Appendix 3

Requests for Further Information and Responses

Resource Consent Application – Further information request

Application number: SP/0179/20
Applicant: 3MS Of Cambridge Limited Partnership
Address: 1881 Cambridge Road Cambridge 3434
Proposed activity(s): Subdivision to create 242 residential lots within the C2 Growth Cell, and associated lots for public assets

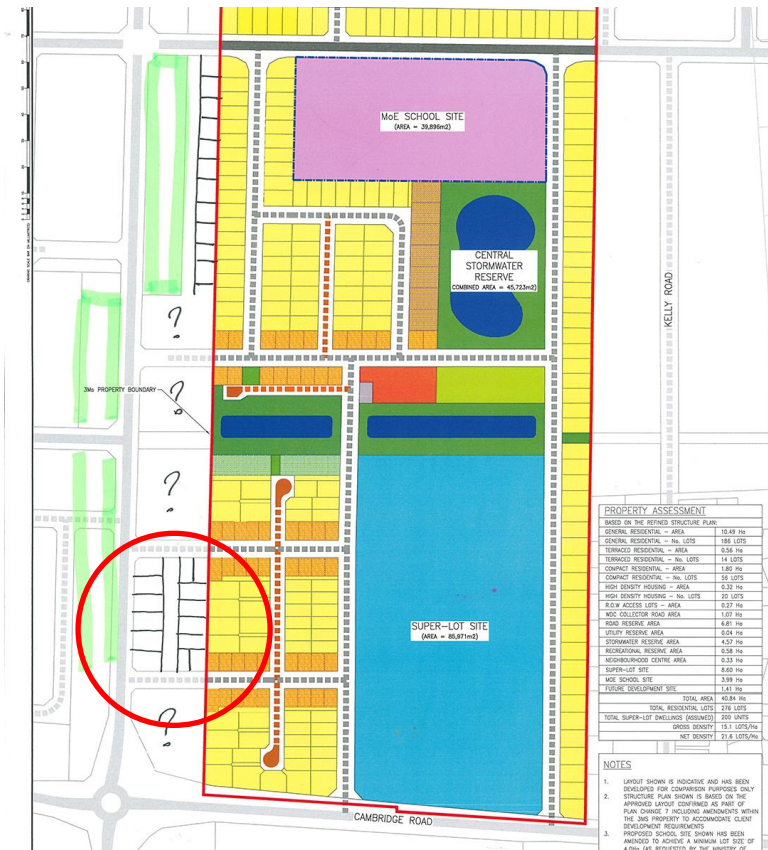
The proposed layout within the 3Ms site on its western side, suggests that the adjoining land along the length of the western boundary of the site through to the north-south collector road (as shown to be repositioned in the 3Ms indicative Structure Plan) may not be able to be developed in a manner that would avoid significant use of rear lots, private laneways / JOALs, or single lot depth blocks with, for example, the collector road on the western side and a potential local road on the eastern side. The District Plan discourages rear lots and single lot depth blocks.

This raises the question of the suitability of this outcome on the adjacent land outside the site and what other outcomes may arise from the design approach proposed. No assessment with regard to policy 15.3.1.1 is provided.

At a Friday 19 March meeting with Abbie Fowler, Council's consultant urban designer, Matt Riley, shared his high-level thoughts as for how the land to the west might be developed by a landowner, presenting one option he has tested (see below – Red circle) that would produce undesirable urban design outcomes (eg: single lot depths) or, while potentially having vested north-south local roads, has doubtful viability. This is also an offsite effect.

- a. To assist the Council to consider the suitability of the layout of the proposal in this regard, please provide urban design analysis in this regard. The expected analysis should include indicative layout options for the adjoining land to the west of the 3Ms site, showing how it could be developed in a manner that minimises and ideally avoids the use of rear lots and private laneways.

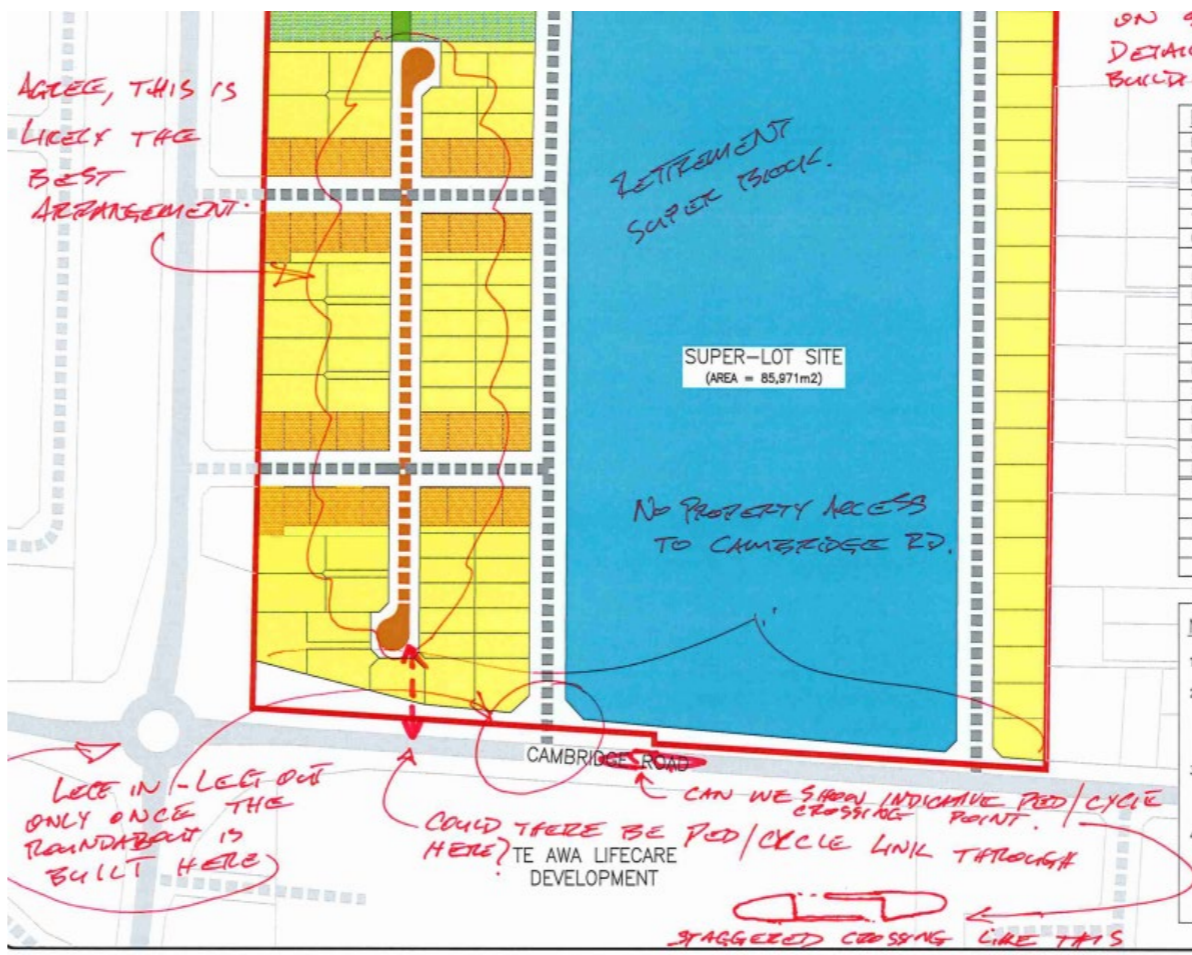
As part of this design exploration, it would also be desirable to understand – as a consequence of the proposed 3Ms layout - what would the likely lot layout be on the adjoining land directly to the west, to the east of the north-south collector road? Could rear lots be avoided on that land? How would future lots on that land be accessed? These questions are relevant to the overall outcome of achieving positive street frontages and an integrated urban form.

Responses to the queries to the left are requested – noting that, where appropriate, this may require aspects of layout design.

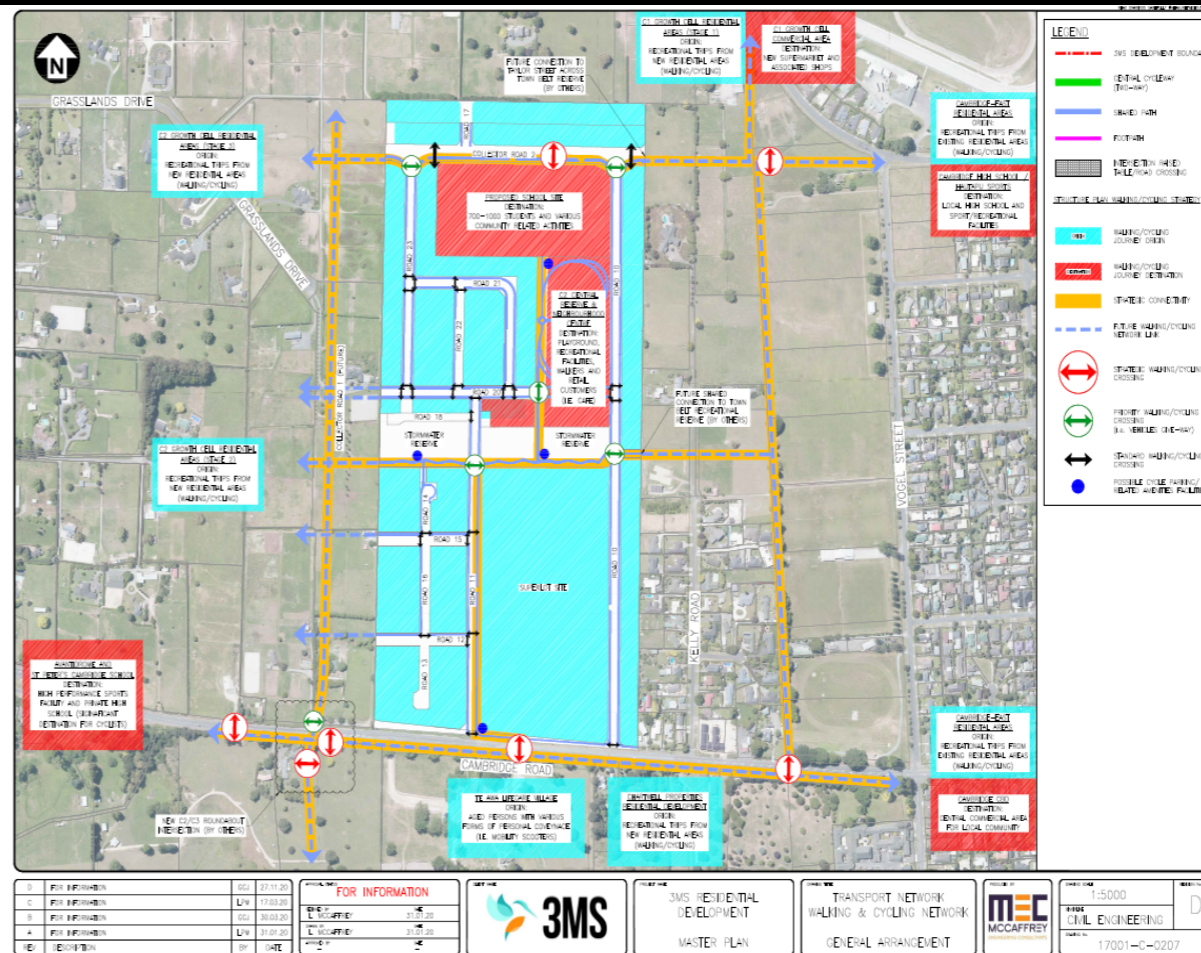
(2) whether positive interfaces will be achieved to the east-west reserve lots;

(3) the degree of permeability through the retirement village lot 300 and cul-de-sac road 13.
